LiDAR Quality Assessment Report

Materials Received:	Projec
2/14/2013	Trojec
	Projec
Project ID:	This I
ME_Aroostook_2012	three
	the M
Project Alias(es):	Ortho
Maine Statewide Lidar	areas
	Clean
	FVA v
	areas

This lidar project, Aroostook, is part of three, non-contiguous areas as part of the Maine Statewide Lidar and Orthoimagery project. The other two areas are referred to as Mid-Coastal Cleanup.

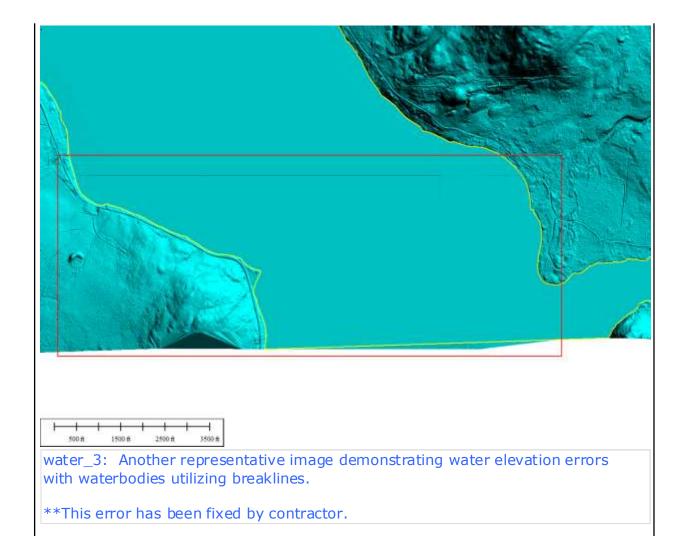
water_1: This is a representative image of water errors whereas breaklines are provided for a waterbody, however, elevation of the waterbody is not constant (specifically for ponds/lakes). There are five of this error type.

**This error has been fixed by contractor.

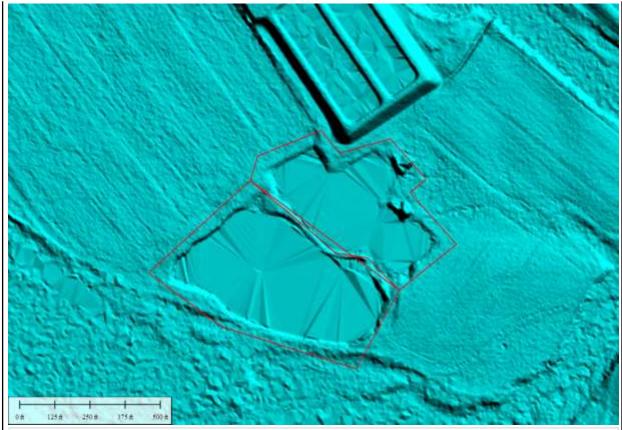
unflattened_wb_2-3: This is a representative image of two waterbodies (>2 acres) that are not flattened. There are four errors of this type (two are presented here). These error-types are also related to why the "No missing or misplaced breaklines" box is not checked.

**These errors have been fixed by contractor.

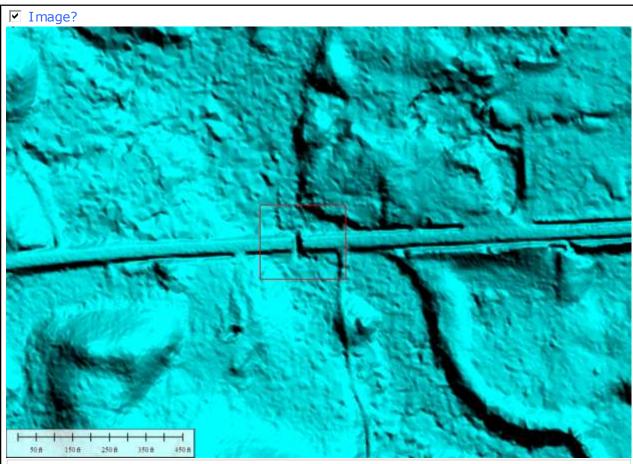
bridge_1: Imagery suggests the presence of a bridge (not a culvert) at this location; the roadway was not removed. There are two of the this error type.

**These errors have been fixed by contractor.

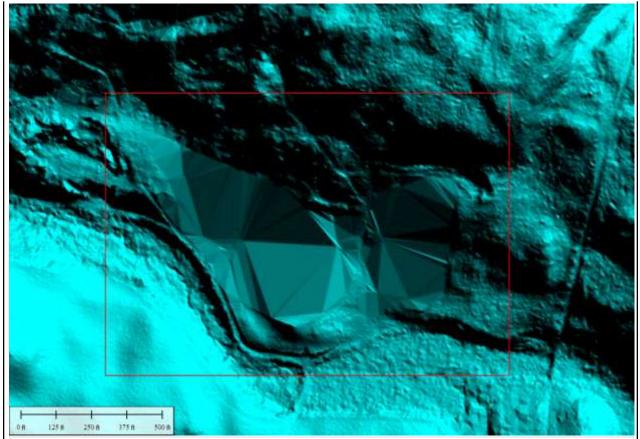
culvert_1: Imagery suggests that the roadway removed in the red box covers a culvert and that the location is not a bridge. Roadways over culverts are not to be removed according to USGS Lidar Guidelines and Base Specifications Version 13. This is the only error of this type.

**This error has been fixed by contractor.
